County of Fairfax, Virginia

STAFF REPORT

APPLICATIONS RZ/FDP 2011-MV-031

PROPOSAL: Remove the existing office building and develop a mixed use development. The proposed development would consist of a 370,000 square foot multi-family building for up to 390 dwelling units, 260,000 square foot office building (including 6,000 square feet of ground floor retail) and 110,000 square foot hotel with up to 200 rooms.

SHEET 25 OF 35
 TLT No. RZ-12622

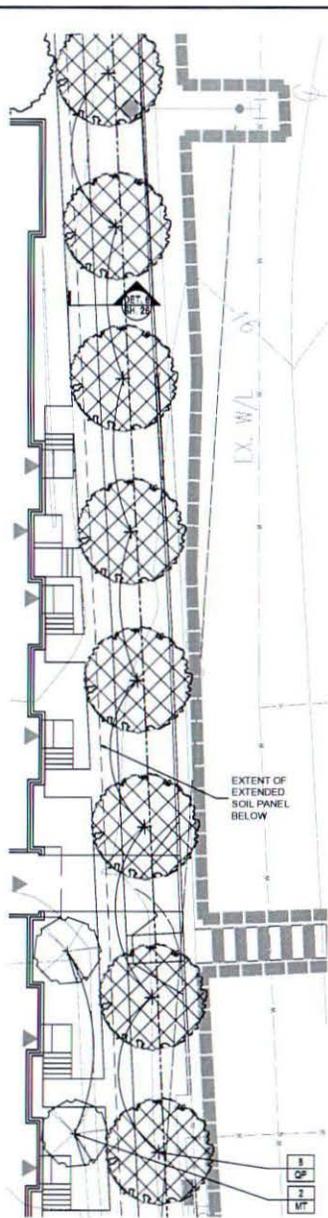
4. **Comment:** The legend on sheet 25 of the development plan refers to certain planting techniques or approaches in providing plantings, including with the Resource Protection Area. However, details have not been provided.

SHEET
26
OF
35

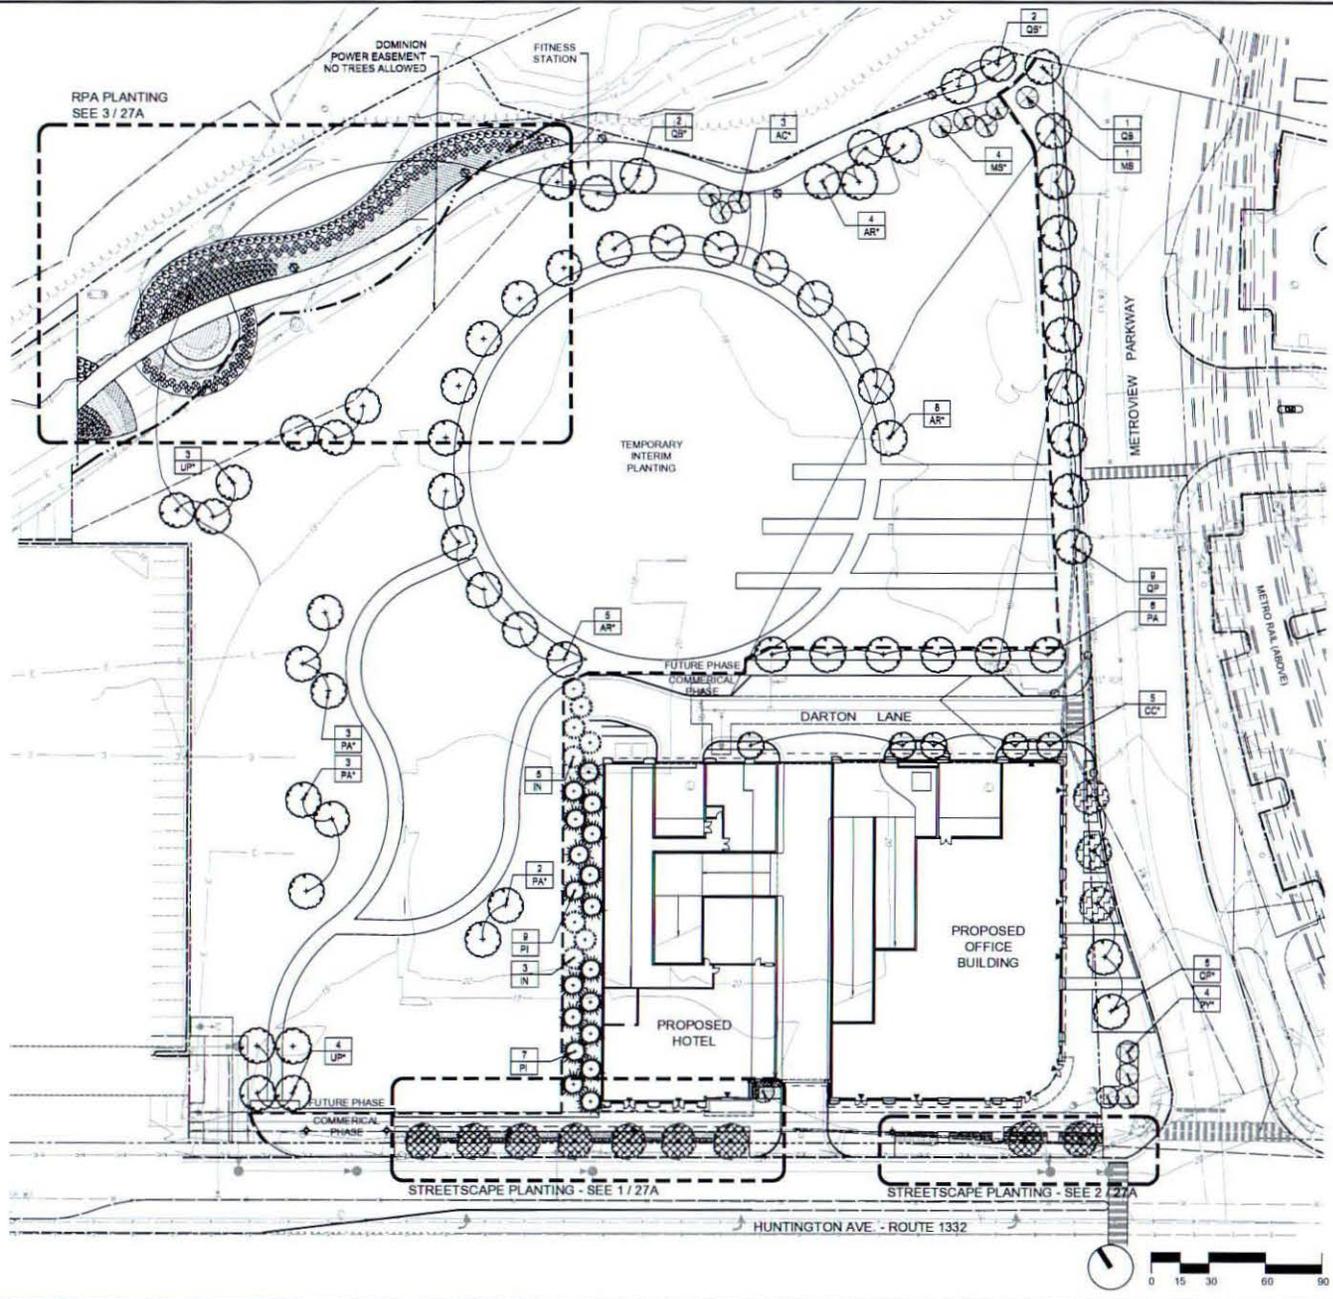
5. **Comment:** The plant schedule on sheet 26 of the development plan should be revised to show either Norway spruce or deodar cedar in lieu of cryptomeria because they are hardier trees. The reference to crape myrtle should include the cultivar "Natchez" on the plan for canopy credit.

Images from plans dated 8/6/12. On left, plan view showing rounded building corner. On right, rendering showing the rounded building corner entrance and treatment of the garage levels above the lobby.

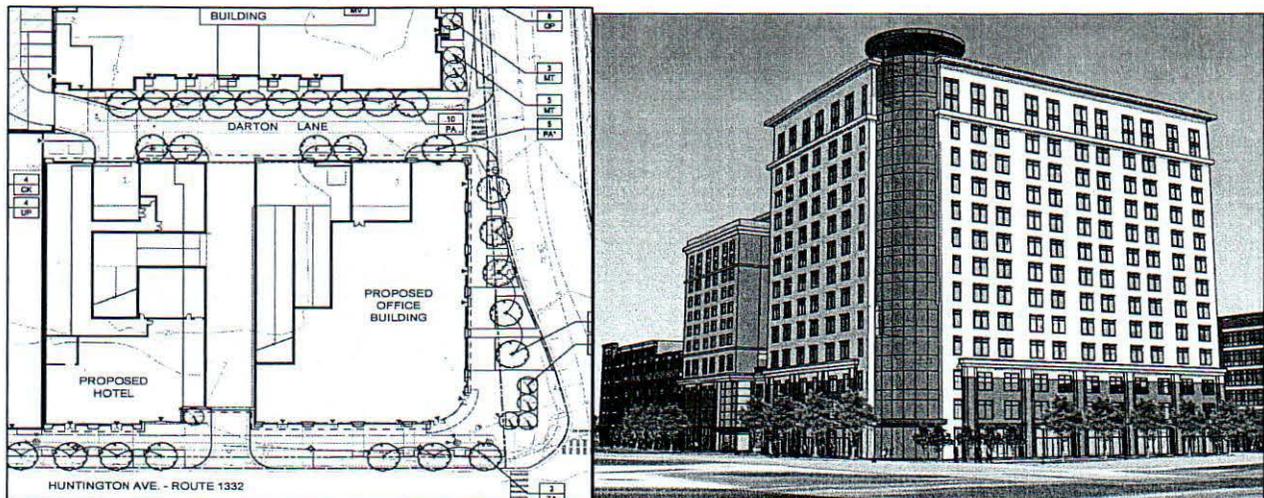
The applicant has provided a redesign of the office building to round the southeast corner as shown in the previous image, and provide the main entrance of the tower within this corner. The images below reflect these changes in the development plans and renderings, as well as showing the architectural treatment of the parking levels above lobby level.

The remaining concern is that some of the improved design changes the applicant is now proposing are reflected through elevations and exhibits in the plans that are noted as 'illustrative only.' The scaled section drawings provided on Sheet 7 show only the residential component and associated parking garage. This is problematic in that several changes the applicant is proposing that make the redesign acceptable are not formalized in the plans. It is expected the applicant will remove the 'illustrative only' text from all plan sheets and also correct any discrepancies between the dimensions in those sheets currently labeled as 'illustrative' and other plan sheets. Assuming the applicant provides these changes, this alleviates the above-stated concern.
